The National
Pharmaceutical
Service Network

RE: NRC Materials License # 37-18467-01MD, Pittsburgh, Pennsylvania

Please amend our Nuclear Regulatory Commission Materials License Number 37-18467-01MD, Pittsburgh, for authorization to make the physical change in our equipment layout. These changes will isolate the handling of volatile substances to a single room allowing better control, and isolating this material to a specific area. No changes in the ventilation information for the fume hood system will be made since the same exhaust stack presently used for the fume hood will be the same for the new location of the fume hood.

EXHIBIT A

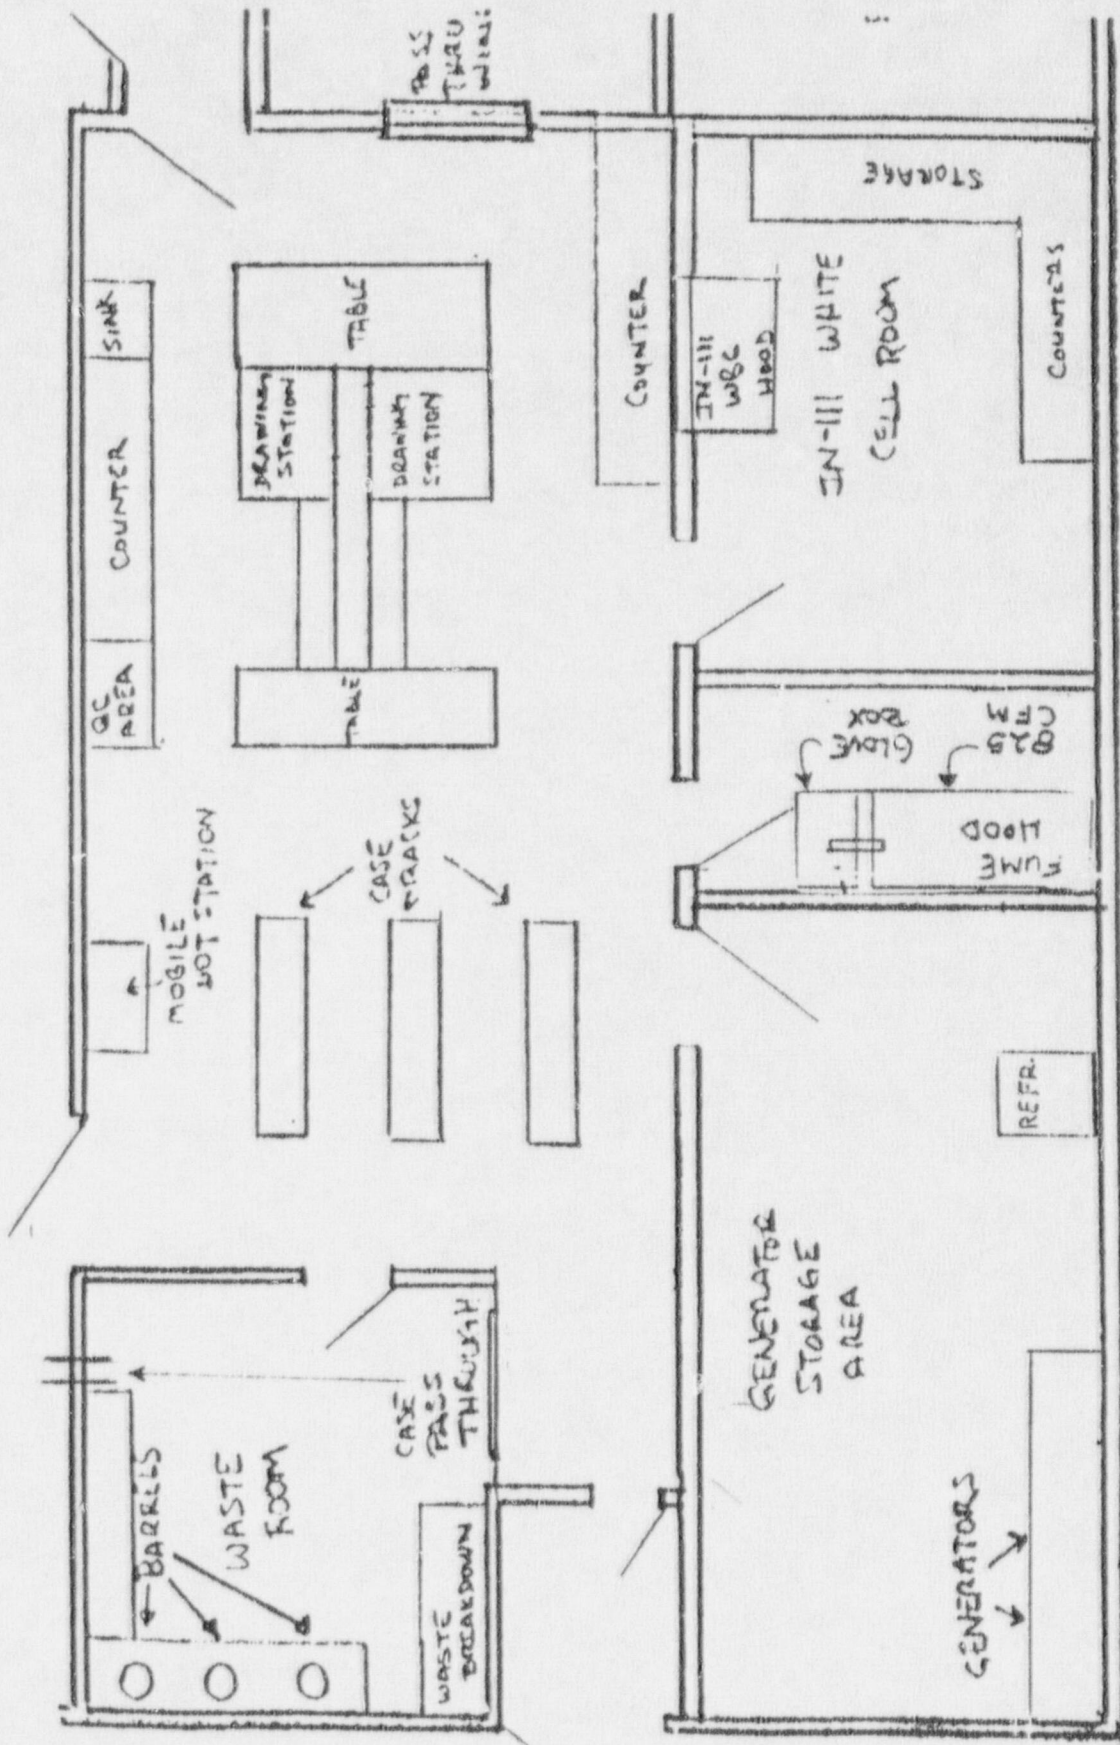
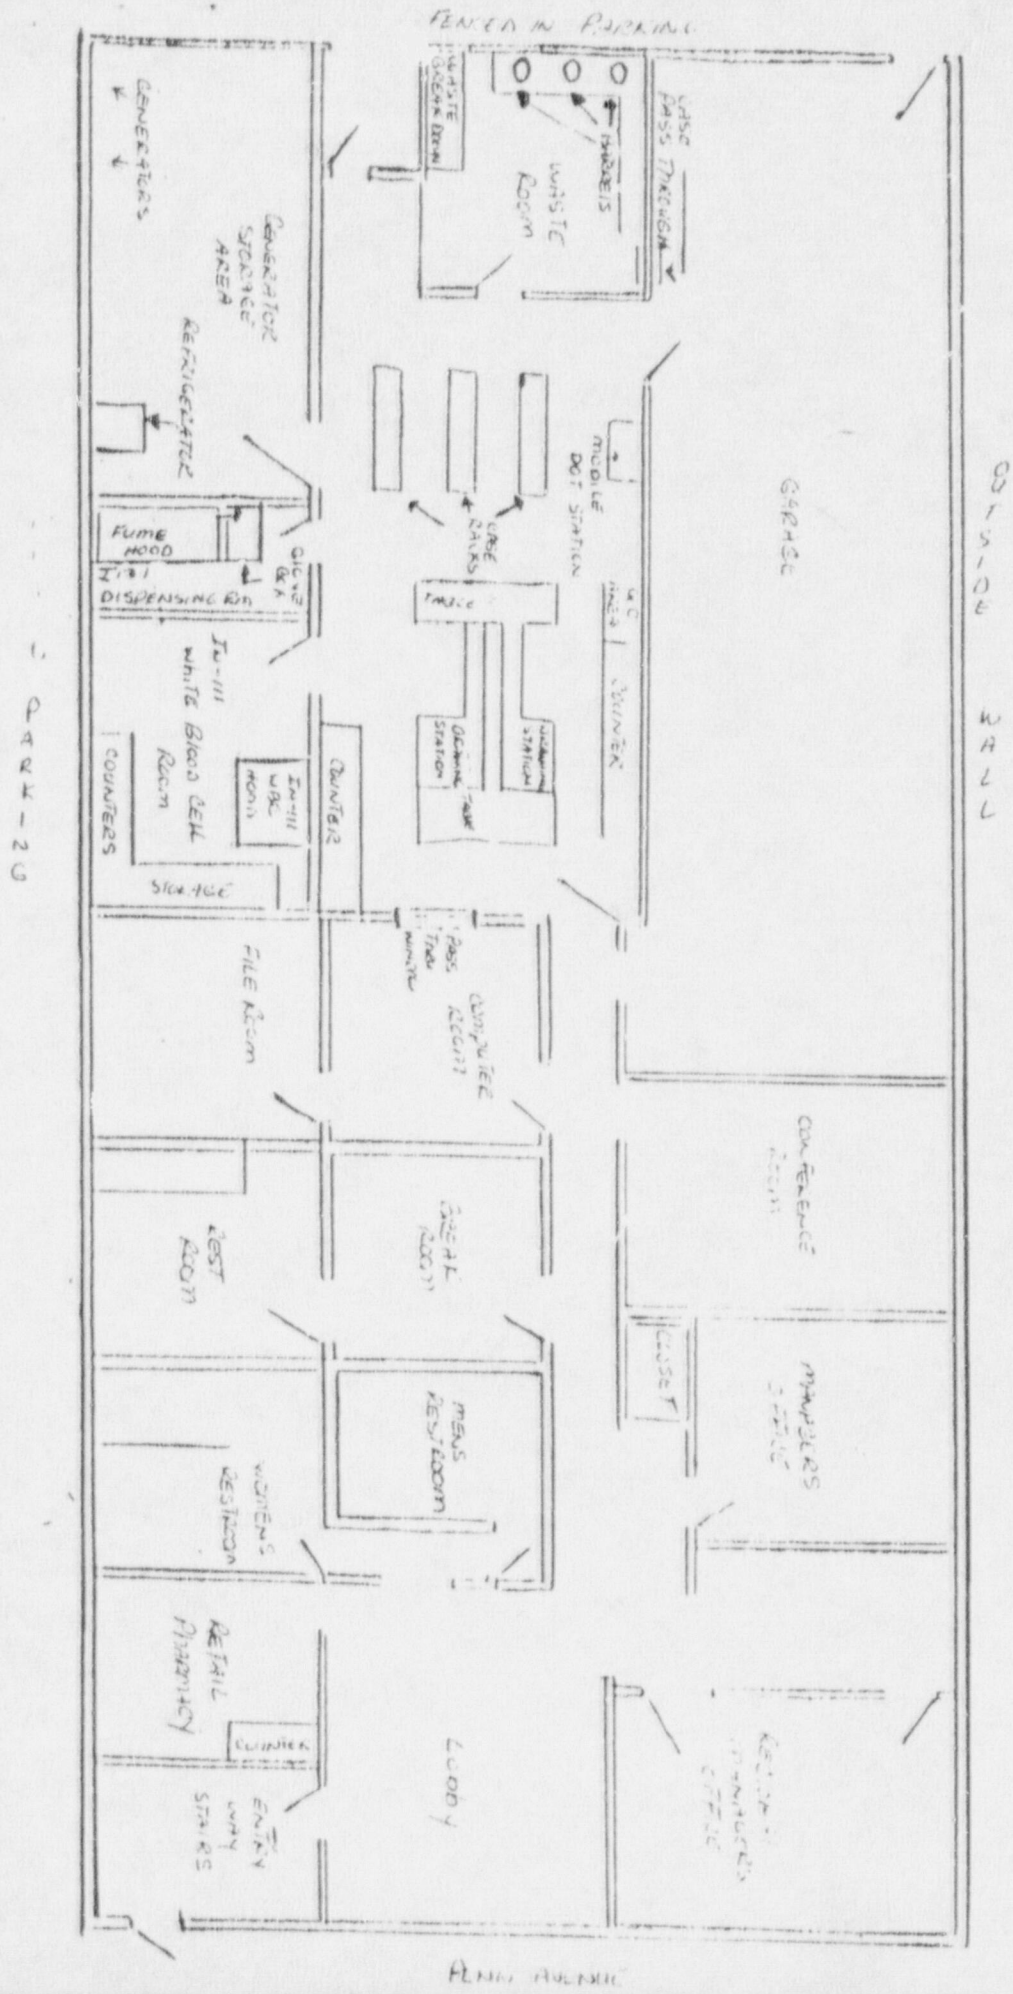
I have enclosed sketches of the new layout, (Exhibit A), and sketches of the old layout, (Exhibit B), along with a new section on facilities and equipment. The changes are to move the fume hood/glove box system from the generator storage area to the room formally designated "the shipping and receiving area", and to relocate the biohazard hood from its previous location to the present location as shown on Exhibit B.
